# **RANCHO SANTIAGO COMMUNITY COLLEGE DISTRICT**

## **ADDENDUM NO. 02**

Bid #1470 VAV Valves Replacements  
at  
District Operations Center

Project ID #2929

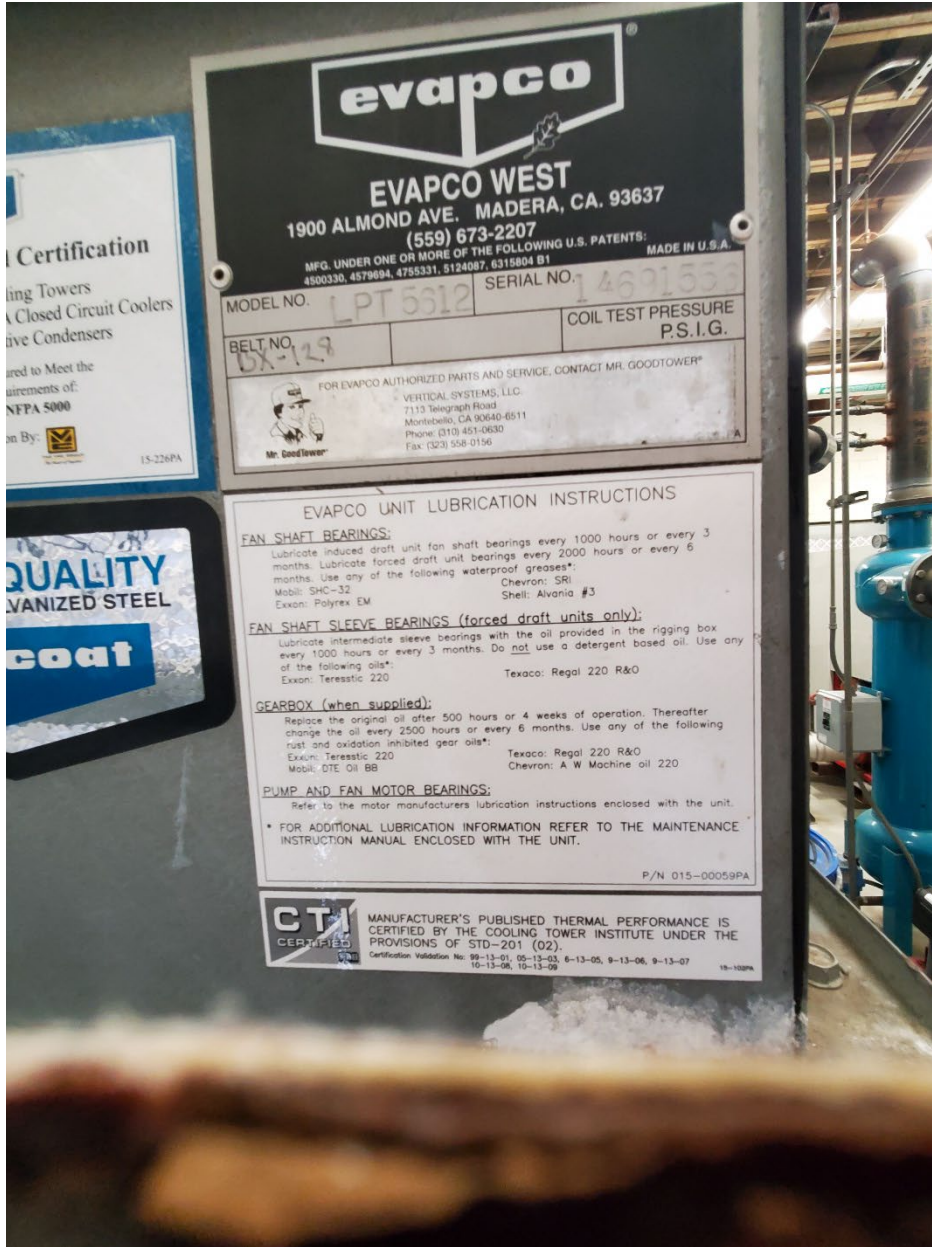
PROJECT NAME:	VAV Valve Replacements Project at District Operations Center		
PROJECT NUMBER:	2929	BID NUMBER:	1470
<b>EMAIL TO: facilitiesbid@rscsd.edu</b>			
DATE:	01/20/2025		
FROM:	Allison Mechanical Inc.	EMAIL:	pgreene@allison1.net
SPEC SECTION:		DRAWING NUMBER:	
<b>REQUESTED CLARIFICATION:</b>			
Please provide a panel location from which 120v power for water level fill control can be used.			
<b>RESPONSE TO CLARIFICATION:</b>			
<p>The panel is located on the roof inside the mechanical room. See included panel location plan below. Answered by RSCCD 1/30/25</p>
